Radiation Center

Reference: Oregon State University TRIGA Reactor, License No. R-106,  
Docket No. 50-243

RESPONSE TO  
NRC REQUEST FOR ADDITIONAL INFORMATION  
DATED JULY 20, 1979

OREGON STATE UNIVERSITY TRIGA REACTOR  
LICENSE NO. R-106  
DOCKET NO. 50-243  
AUGUST 17, 1979

FIGURE 1-R

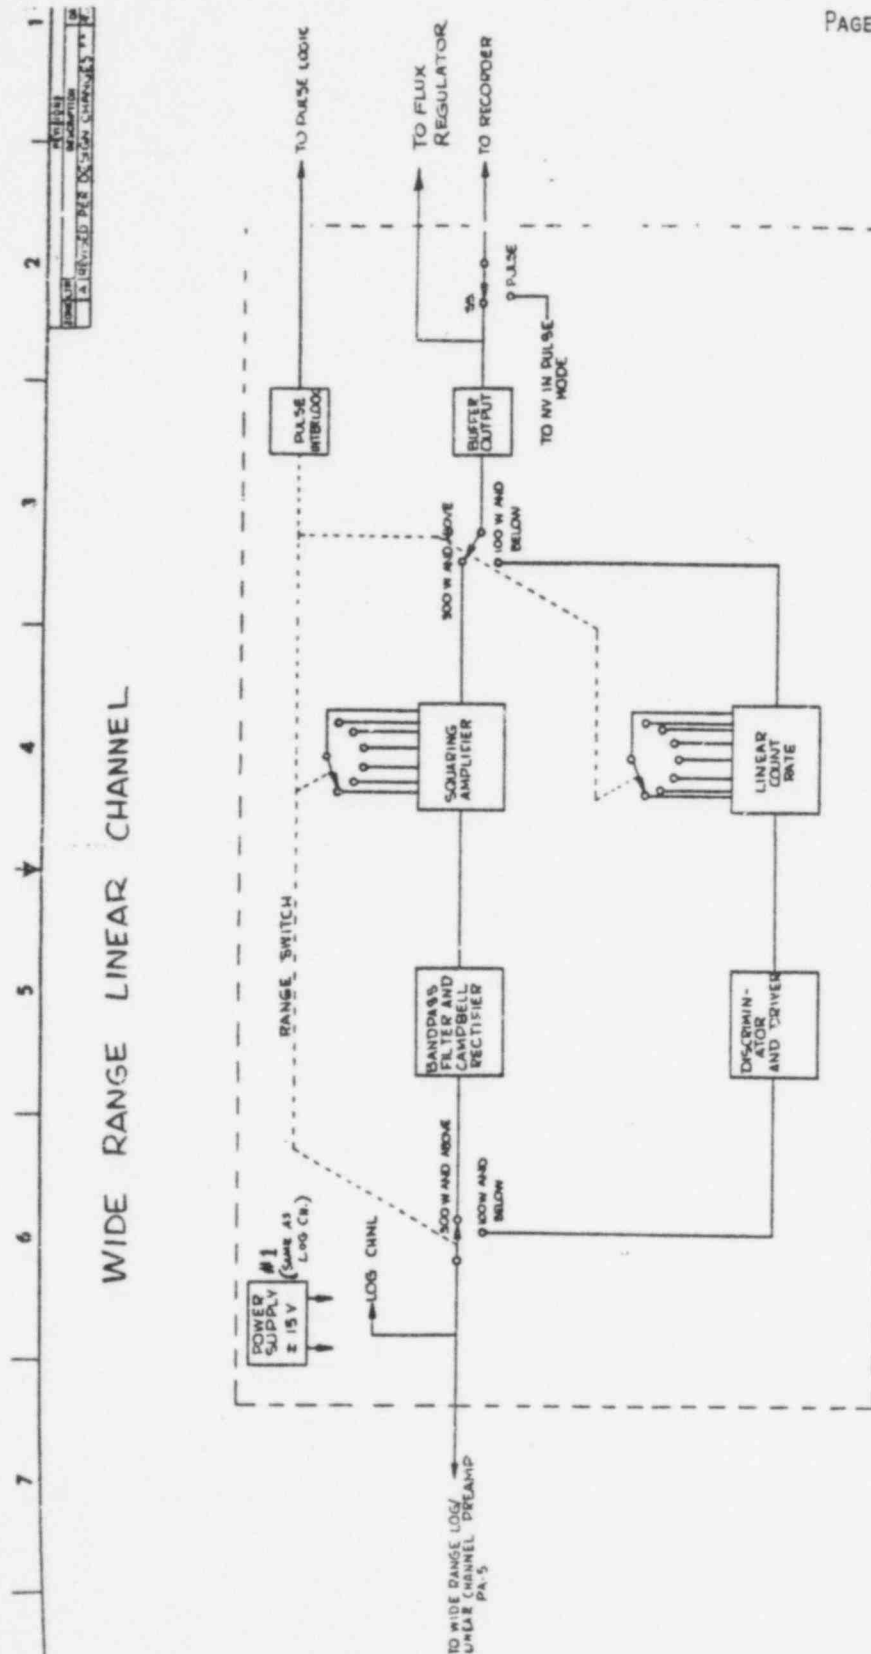
11. The loss of high voltage to the log-linear channel will cause a scram. Figure 2 has been modified (see Figure 2-R) to reflect this.
12. Figures 1 and 2 have been replaced by Figures 1-R and 2-R, respectively. These new figures show that the 1 KW interlock signal is derived from the wide range log amplifier. Figure 2 was correct with respect to the 1 KW interlock and Figure 1 was in error. Figure 1 should not have read, "1 KW pulse interlock." It should have read, "pulse interlock." The pulse interlock, shown in Figure 1-R, is effective when the range switch is in

the "1 MW-pulse" position. The reactor is interlocked such that both the range switch and the mode switch must be in the pulse positions before the pulsing relay (K-2) can be energized. Figure 2-R has also been corrected to show that the period channel is grounded out in both the pulse and square wave modes.

FIGURE 2-R

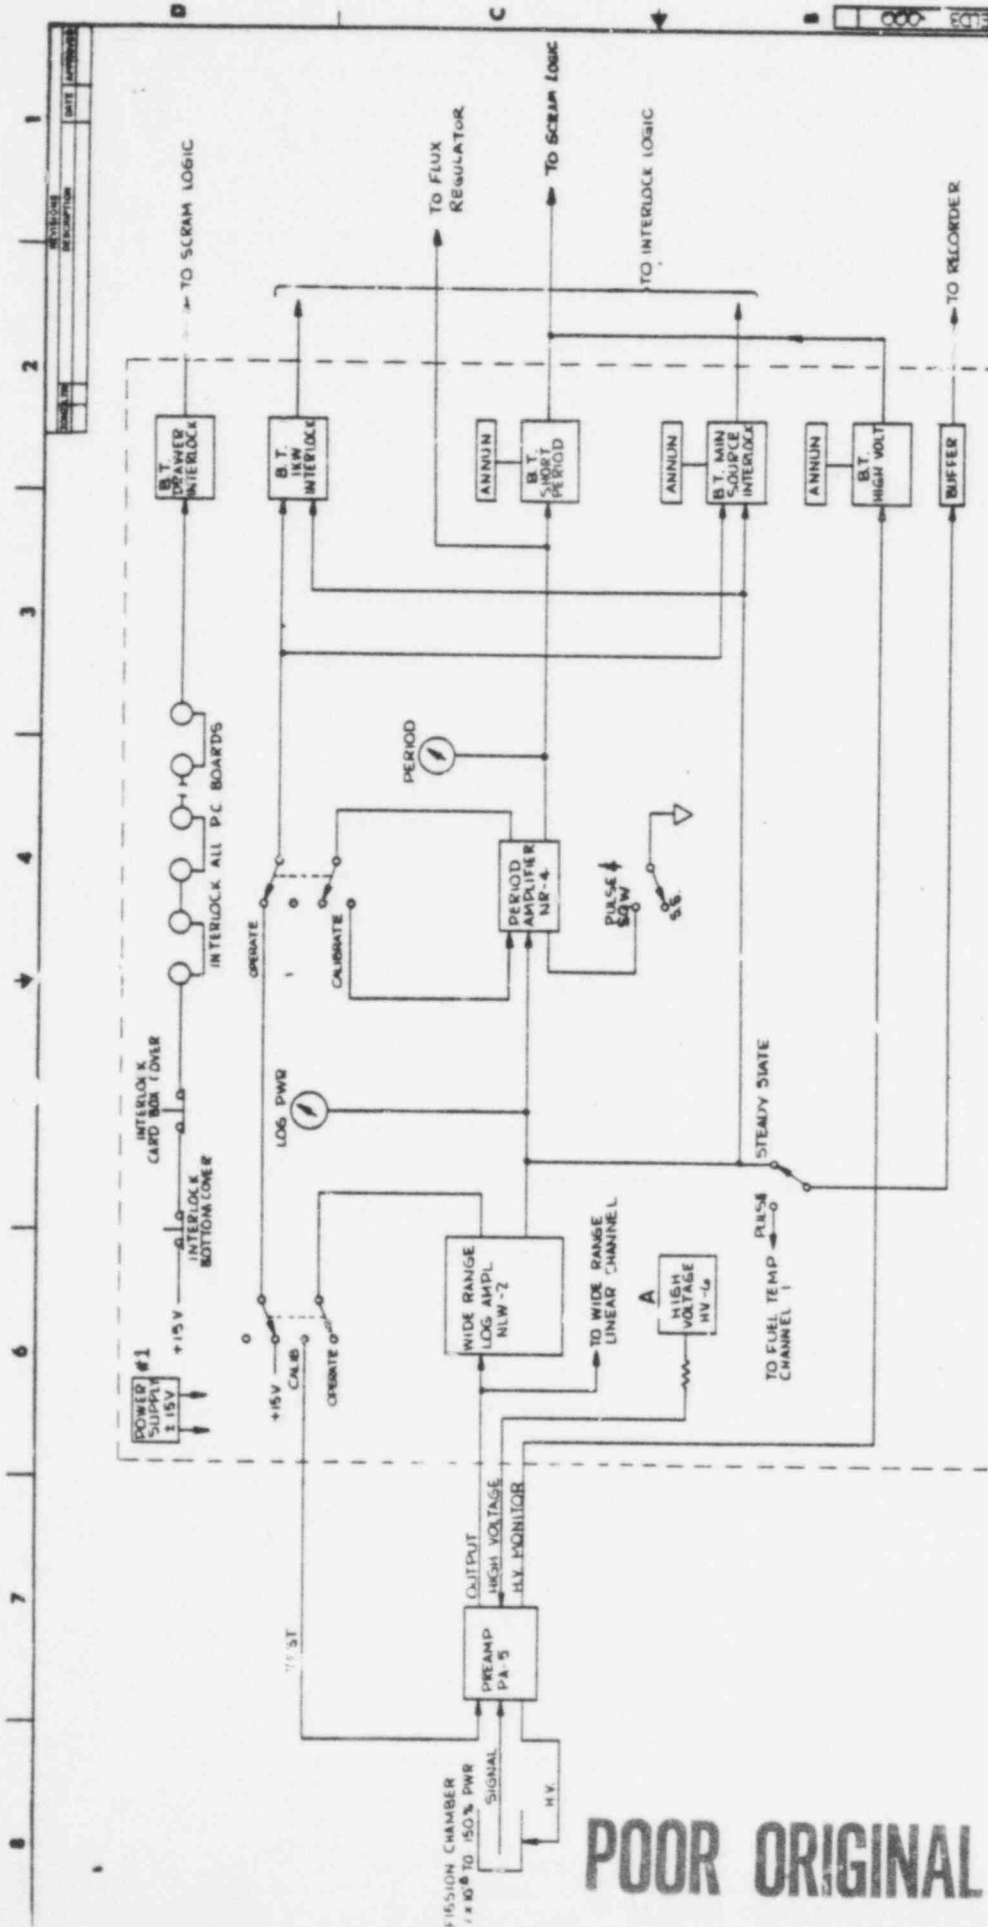
The calibrate circuit diagrams, shown in Fig. 2-R, are simplified schematics representing a more complex system. The one calibrate position shown in the log circuit (Fig. 2-R) actually represents six different calibrate positions (positions 1 through 6 in Table 1). These provide six different calibration signals for both the wide-range log and wide range linear channels. The one calibrate position shown in the period circuit (Fig. 2-R) represents two separate period calibration signals (calibrate #1 and #2 positions in Table 1). In addition, the period trip setting is checked with the PERIOD/LOG TEST switch in the operate position and the PERIOD TRIP TEST switch turned on (see Table 1).

FIGURE 3-R

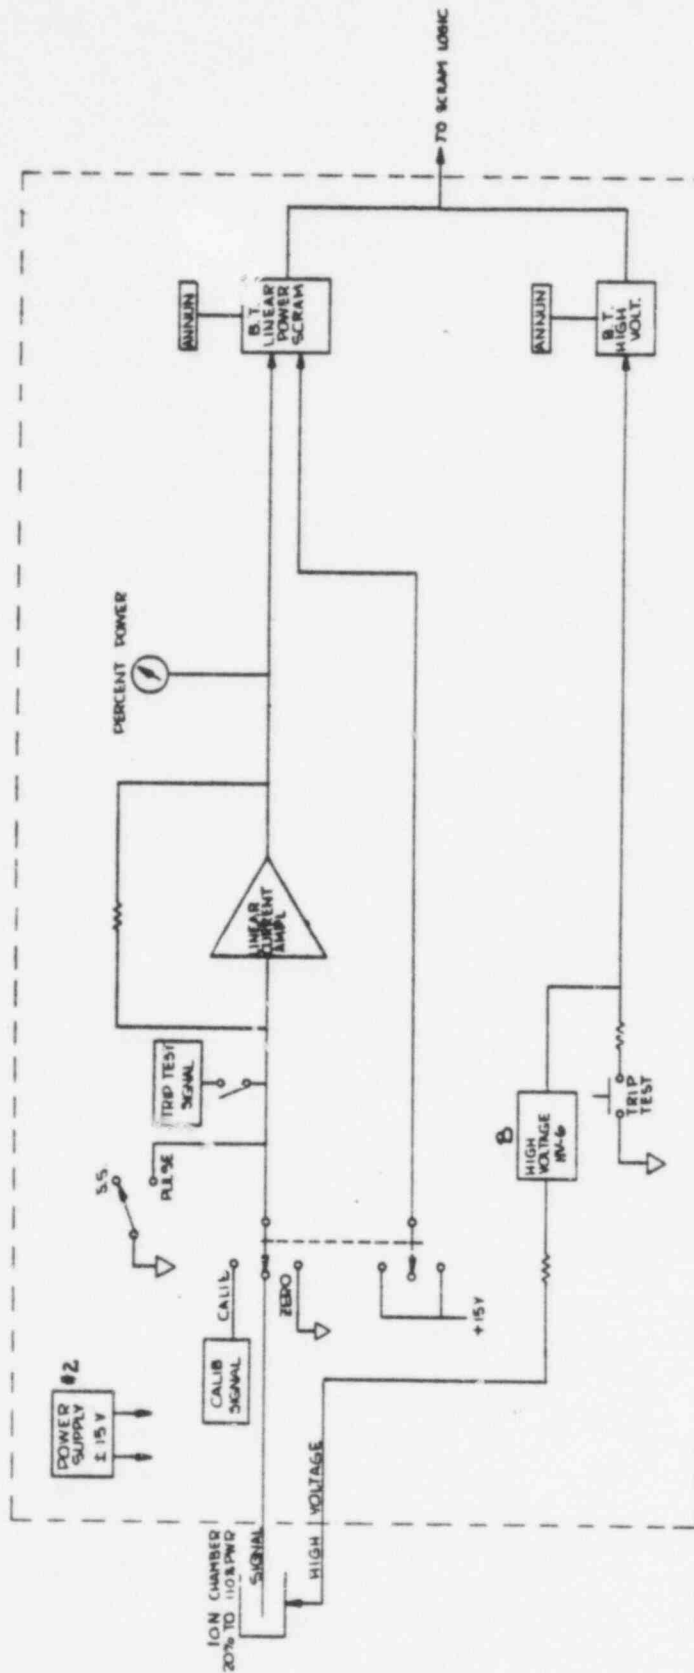
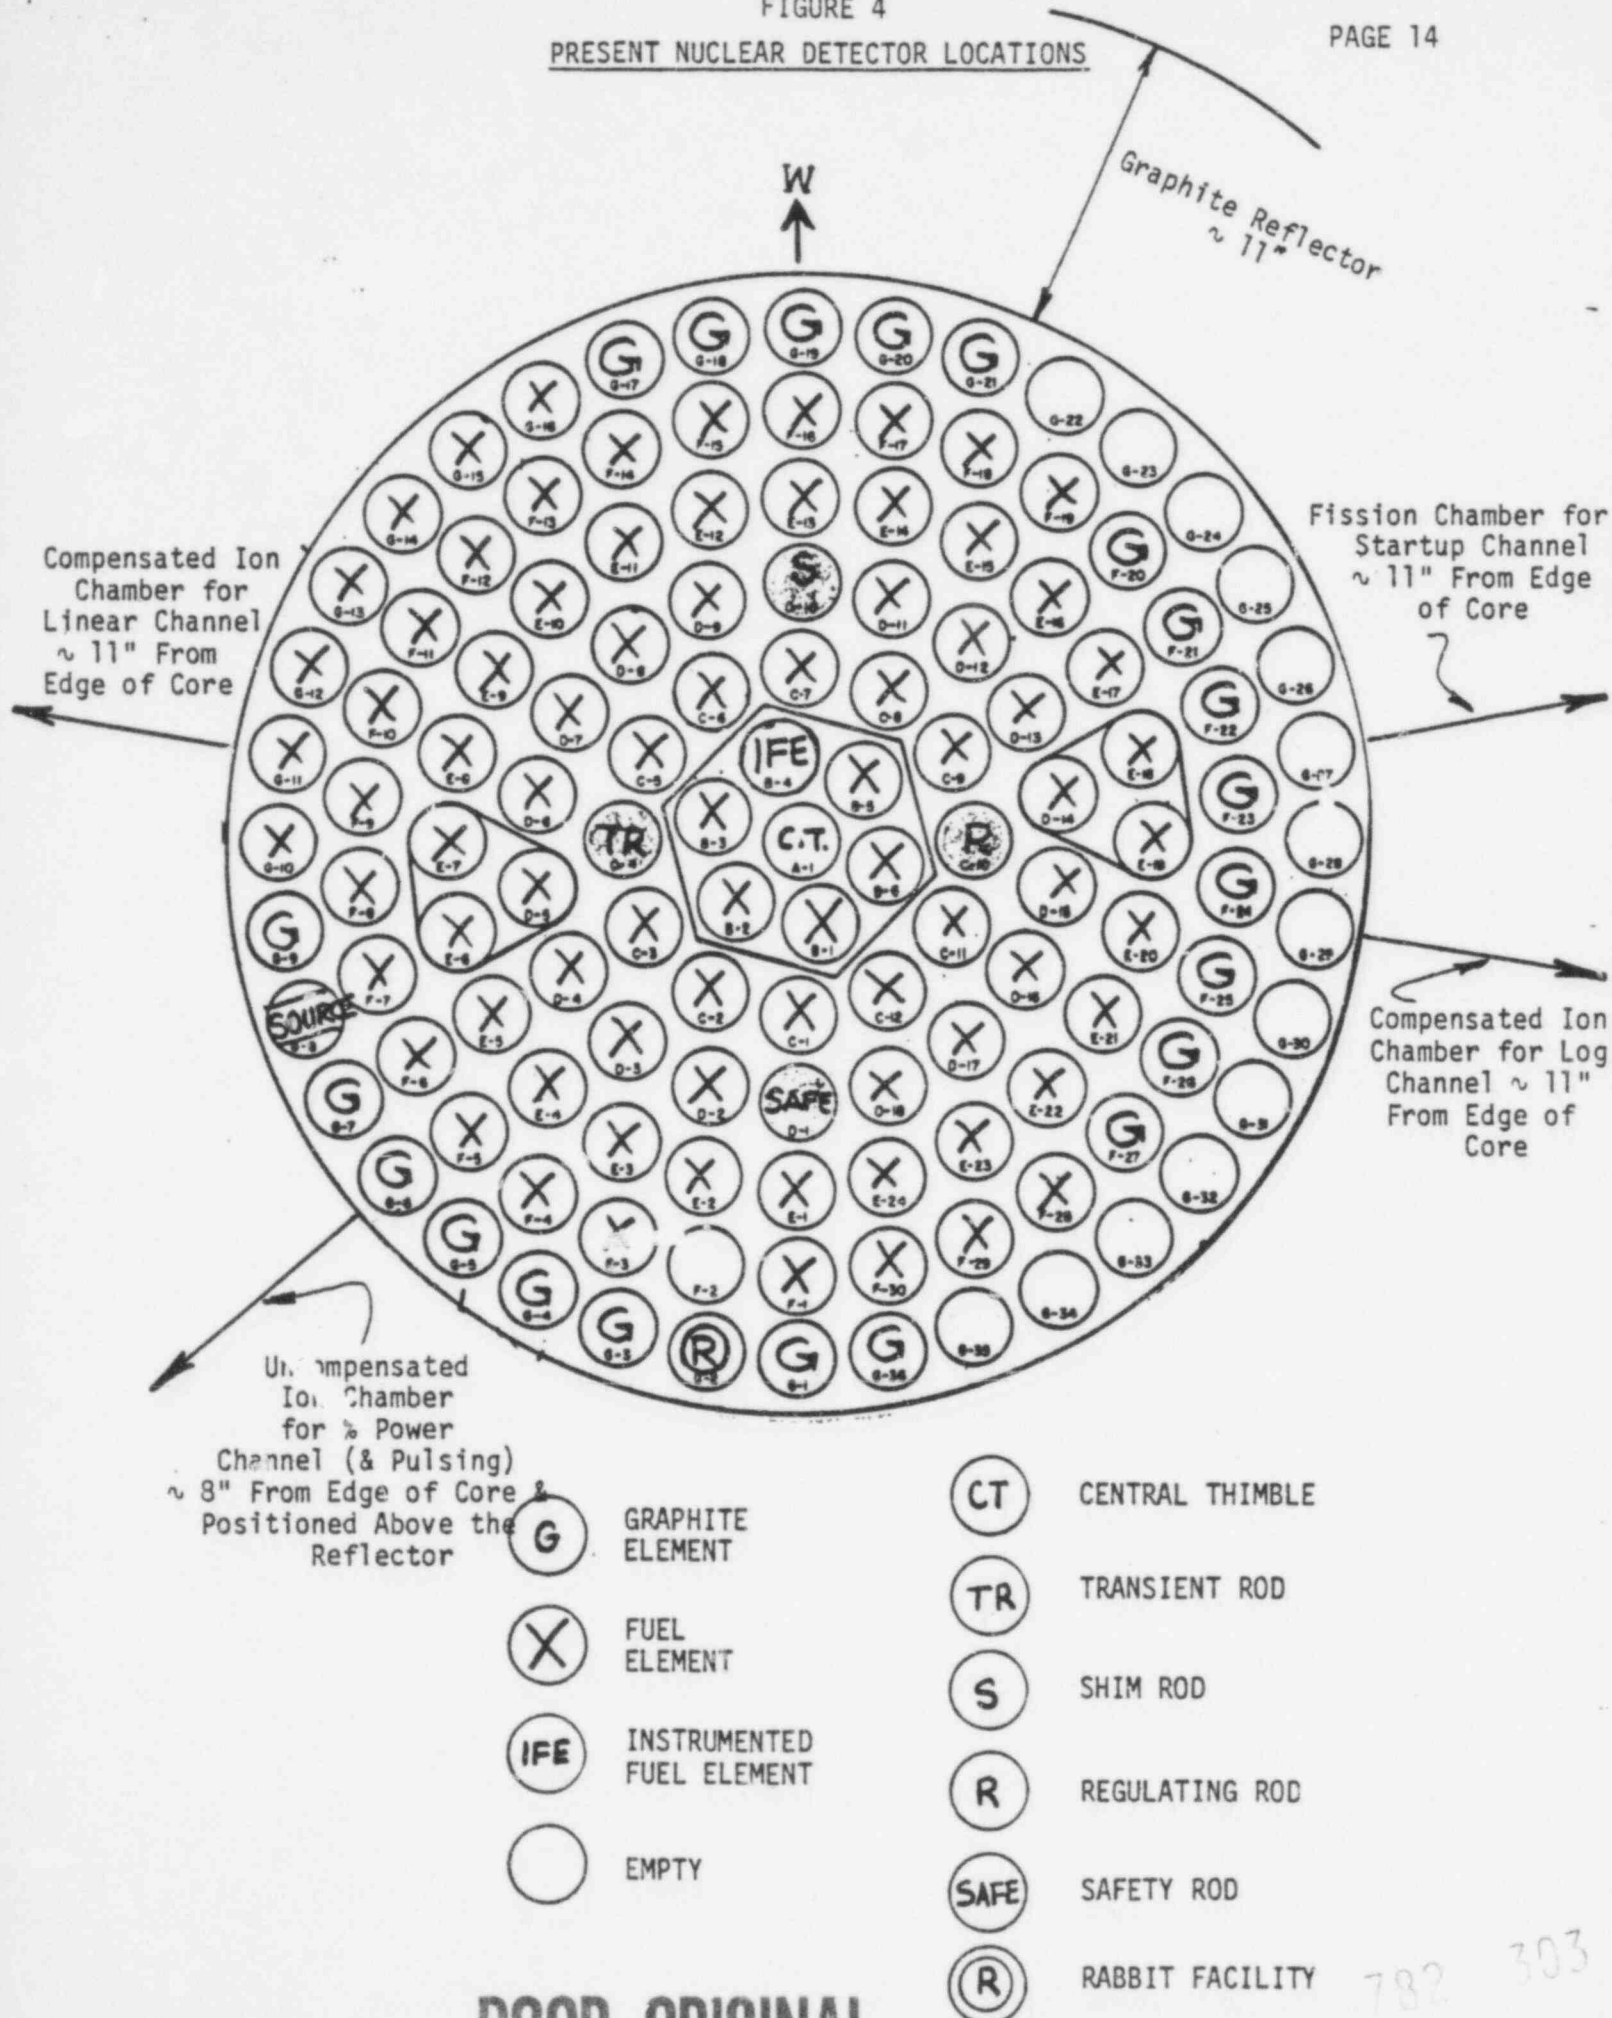
1. The new linear "safety power level" channel and the existing percent power channel will indeed use separate ion chambers. The existing percent power channel will use the same ion chamber and circuitry that is now installed. The new safety channel will use the ion chamber that is presently being used as the linear channel. The compensating voltage for this existing ion chamber will not be used; it will function as an uncompensated ion chamber. See Figure 5 for the locations of the two chambers. The lower left chamber (in Figure 5) represents the existing percent power chamber and the upper left represents the new safety channel chamber.

## PROPOSED NUCLEAR DETECTOR LOCATIONS

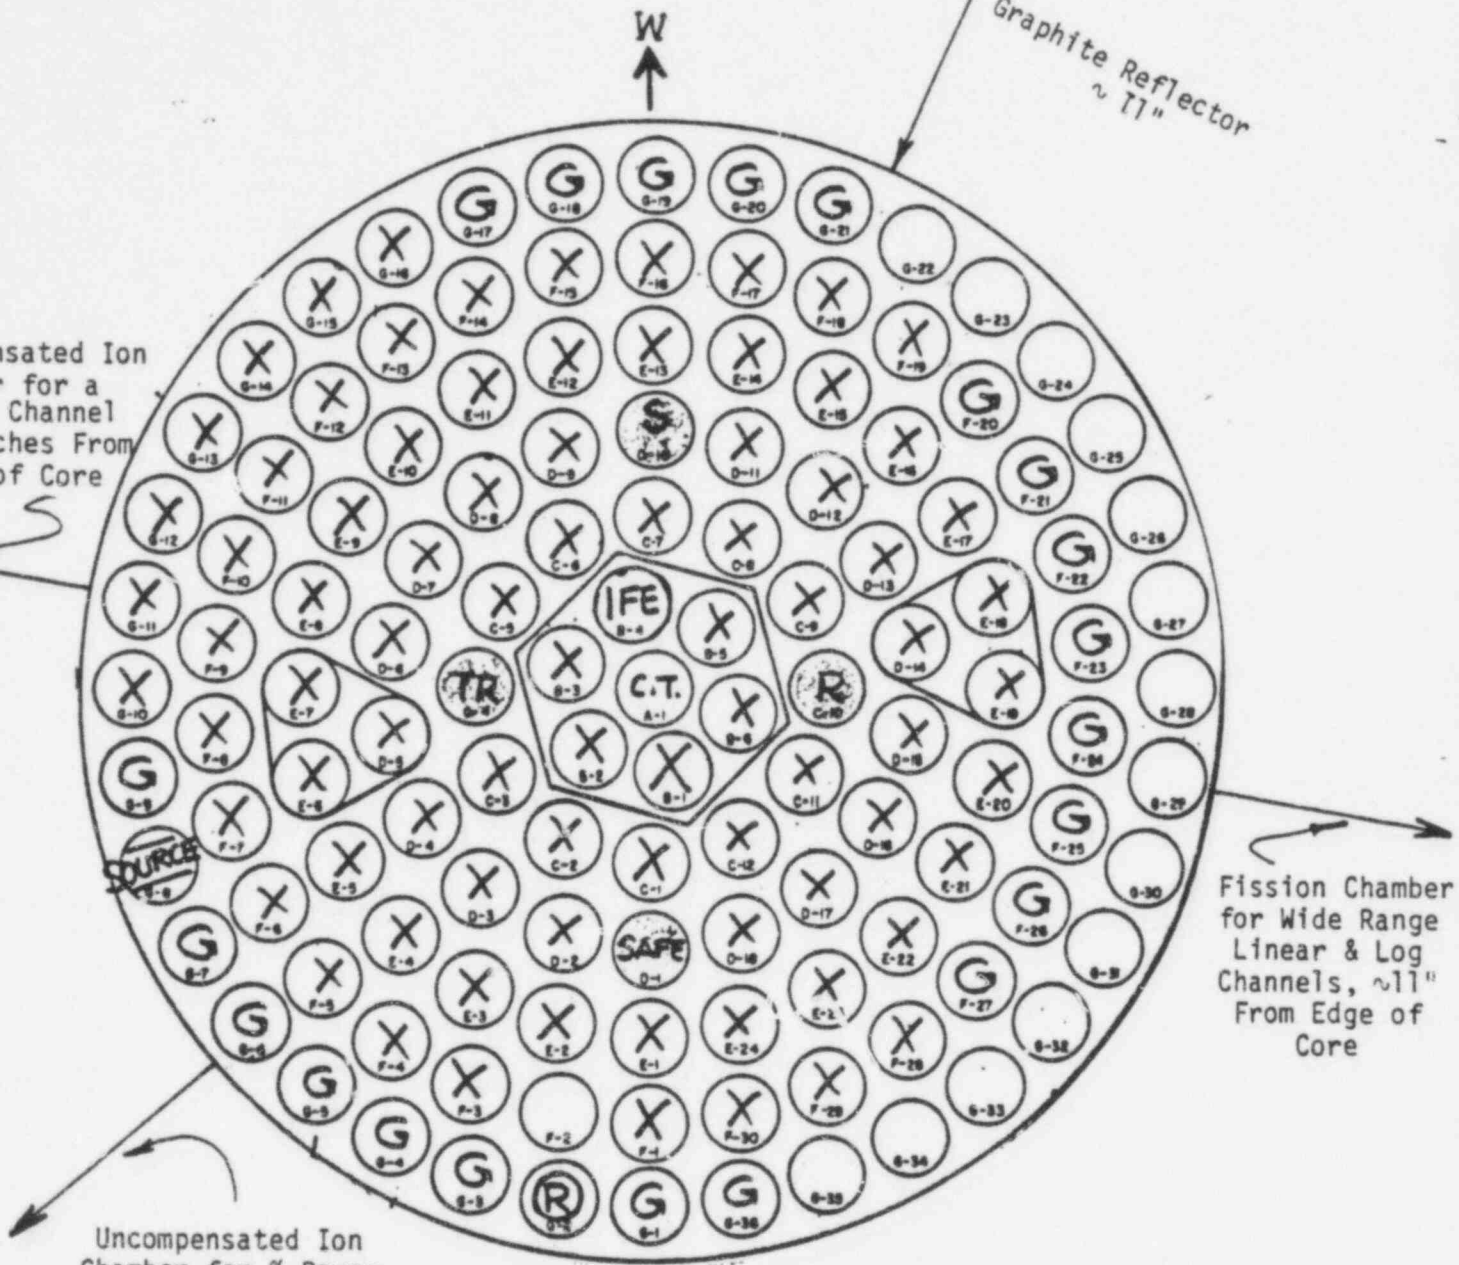
5. Your understanding is correct--the new fission chamber is larger than the existing one. The new fission chamber will be located adjacent to the existing fission chamber. The new fission chamber will be placed into the existing log ion chamber shroud, which will accept the physical size of the new chamber. The existing log ion chamber will be removed and stored. See Figure 4 for the present detector locations and Figure 5 for the proposed detector locations.

The new fission chamber will "see" essentially the same quadrant of the core as the old fission chamber, and source-fuel-detector geometry will be almost identical for either chamber. Any detector shadowing will be essentially the same as the existing fission and log chambers experience now, and this has not proven to be a noticeable effect or problem at all.
